Project	IEEE 802.16 Broadband Wireless Access Working Group http://ieee802.org/16 >		
Title	Clarification of SNR definition for MIMO		
Date Submitted	2004-11-04		
Source:	Peiying Zhu, Wen Tong, Jianglei Ma, Ming Jia, Dongsheng Yu, Hua Xu, Mo-Han Fong, Hang Zhang, Brian Johnson	Voice: (613)-765-8089 Fax: (613)-765-7723 pyzhu@nortelnetworks.com	
	Nortel Networks 3500 Carling Avenue Ottawa, ON. K2H 8E9 CANADA	pyznu@nortemetworks.com	
Re:	Response to Sponsor Ballot call for comment		
Abstract	In this contribution, we propose to feedback CQI based on SNR measured after MIMO decoder and before FEC encoder, so called post processing SNR to provide a unified approach for MIMO CQI measurement. In the proposal, we also clarify the multiple layer feedback using CQICH_Alloc_IE() or Enhanced_CQICH_Alloc_IE().		
Purpose	To incorporate the changes here proposed into the 802.16e D6 draft		
Notice	This document has been prepared to assist IEEE 802.16. It is offered as a basis for discussion and is not binding on the contributing individual(s) or organization(s). The material in this document is subject to change in form and content after further study. The contributor(s) reserve(s) the right to add

Figure XXX Post processed S/N for MIMO

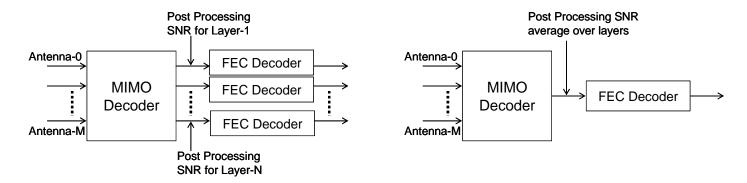
Insert the following text in section 8.4.5.4.10.5 after line 65

MIMO capable MSS shall measure post processing S/N for each individual layers as shown in Figure xxx. When the FAST_FEEDBACK subheader Feedback Type field is "00", the MSS shall report the post processing S/R averaged over layers. When BS requests MSS feedback through CQICH_Alloc_IE() or CQICH_Enhanced_Alloc_IE() with '00' Feedback_type field, MSS shall report average S/N or individual layer S/N as desribed in sections 8.4.5.4.12 and 8.4.5.4.15
